ACTION 4 ALDERHOLT

Planning appeal for P/OUT/2023/01166

Proof of Evidence on Transport and Highways Assessment

Document Number A4A-02

Figure A1.07 Manual for Streets minimum pavement widths for passing vehicles

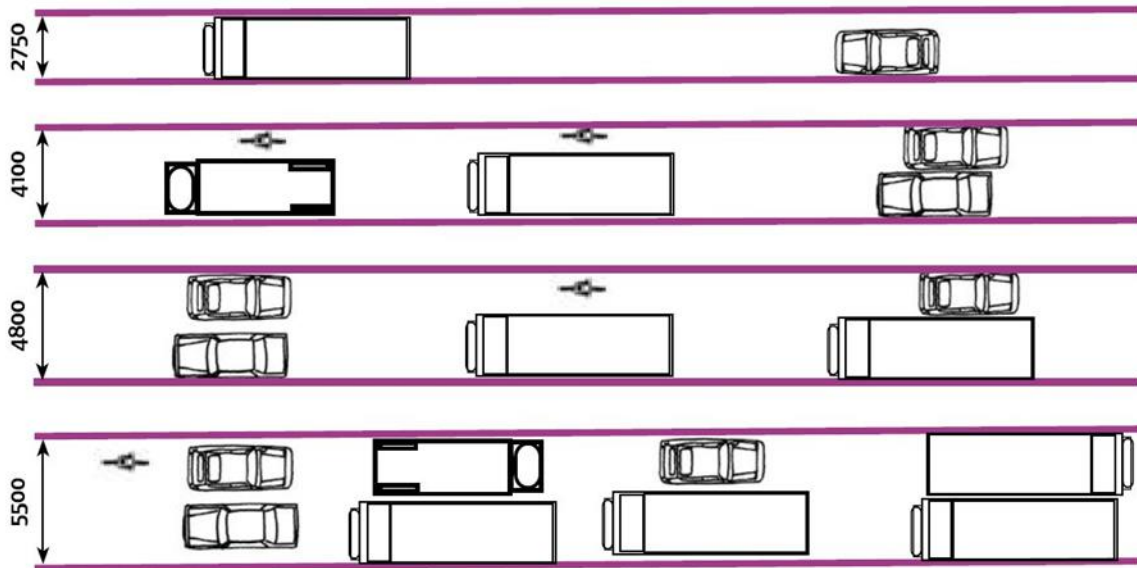
- 4.13 The Manual for Streets, as the name suggests, is a guide is for the design of streets in towns and cities and not rural roads. The manual does state that some of its principles may be applicable to rural roads, but it states: *It is the responsibility of users of MfS to ensure that its application to the design of streets not specifically covered is appropriate.* There is no statement that this has been done. The only reference explicitly made to the MfS is minimum pavement widths required for various vehicles to pass each other and this information is presented at Appendix 1: Figure A1.07. I consider that passing widths on rural roads need to be wider than on streets in urban areas for several reasons. The PBA assessment ignores all of the following factors.
